2017-11-15

Credit Procedure: Reimbursement of Oil Pump Replacement

Bulletin number M1450 must be entered into the comments section of the claim.

Figure 1. Cam Support Plate Tightening Sequence

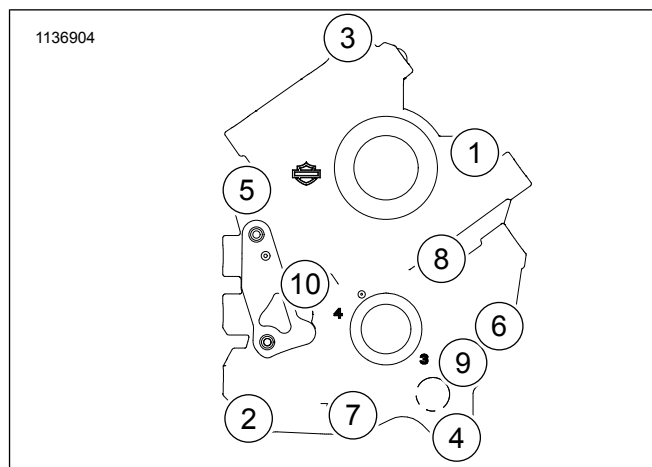
1. Install cam support plate. See the service manual.
2. Refer to Figure 1. Follow modified tightening sequence.
Torque: 10.4–12.7 N·m (92–112 in-lbs)
 - a. Tighten screws 1-6.
 - b. Rotate crankshaft 360°.
 - c. Tighten screws 7-10.
